AFFIDAVIT

My name is Richard D. Parks. I work as an investigator for the Government Accountability Project (GAP) in the Diablo Canyon Power Plant (DCPP) Investigation. I am providing this sworn statement to evidence concerns over a problem at DCPP.

These documents relate to Residual Heat Removal (RHR) Pump #1 Recirculation Valve (FCV-641A- Unit 2), and its associated hanger #413-143 SL. On page 40 of Attachment 1, this valve is listed as being Environmentally Qualified. Attachment 1, pages 37-41 explain the significance of this qualification.

SUBJECT 413-143SL REV 0 SEQUENCE NUMBER QF-2-6916
CLASS 1-B

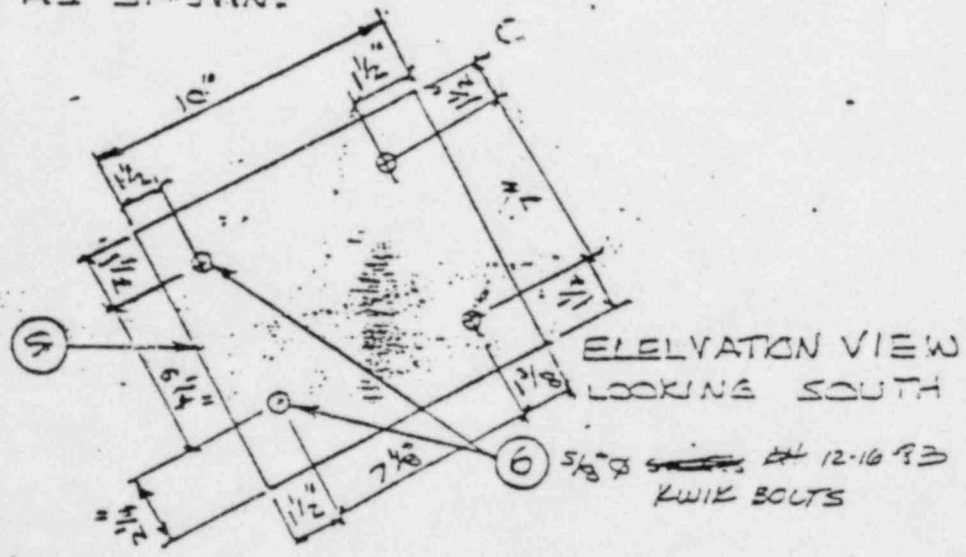
DESCRIPTION: BOLTHOLE LOCATION ON BASE R 5
AS SHOWN:

IS THIS ACCEPTABLE?

THIS IS ACCEPTABLE
